**APPENDIX A - URBIS' RESPONSE TO THE COS AND DPE SUBMISSIONS**

## **The Star Modification 13 - Landscape Design**

Response to Letter received from Alex Greenwich and the City of Sydney Submission

# ROOF TOP - CLUB LOUNGE

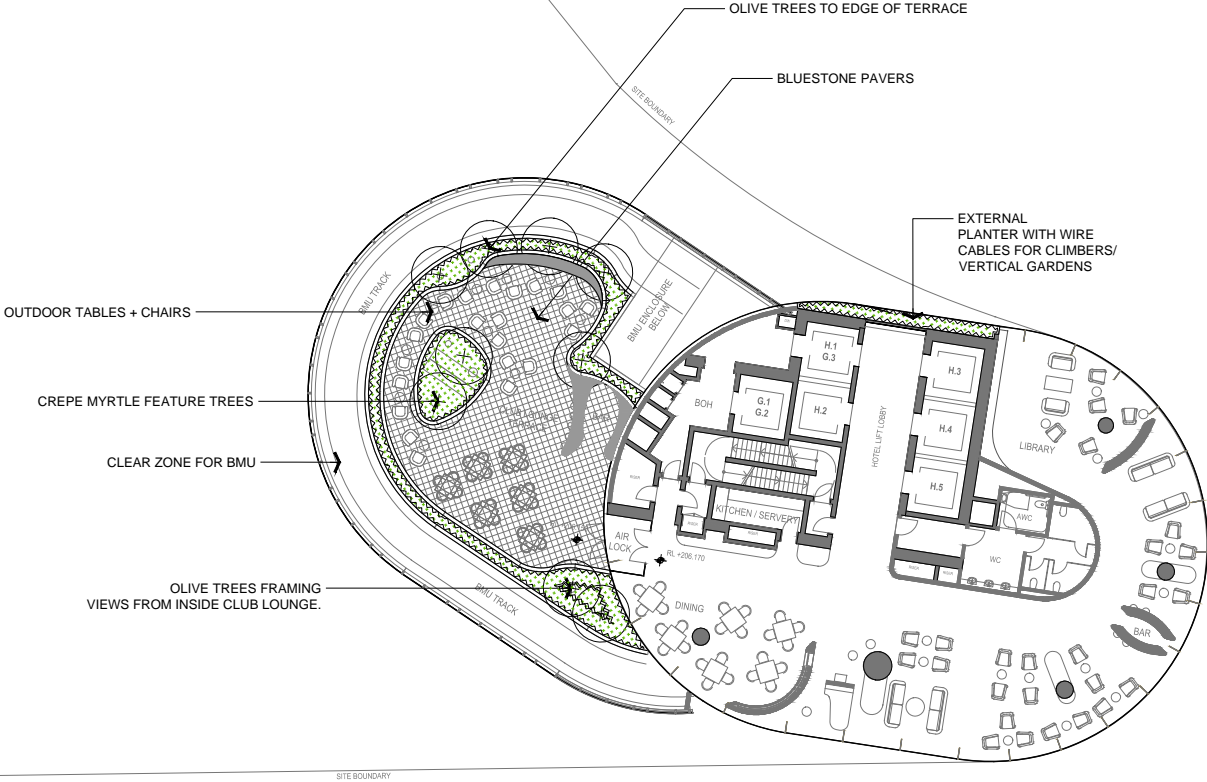
*•The Level 59 Club Lounge description does not match the plans. There is no wind study evidence to confirm that the landscaping proposed has been designed to withstand the western aspect and likely wind effects. Is the proposal achievable at upper levels of the tower?*

The description has been updated to match the latest design. The Wind Consultant has reviewed the landscape design and with the architects are proposing a 2m high glass balustrade to the perimeter of the terrace.

# GREEN SPINE - TYPICAL FLOOR PLAN

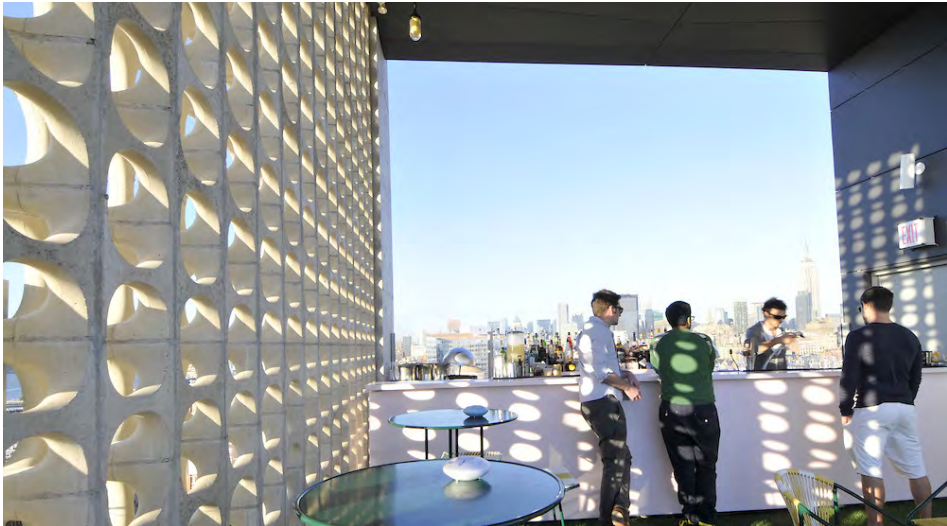
*There is a lack of detail provided to understand the proposed scheme.*

Refer to Junglify Report (Appendix B) and architect's drawings (FJMT, Façade Details, Western Seam planter details, SM13 AF8302).
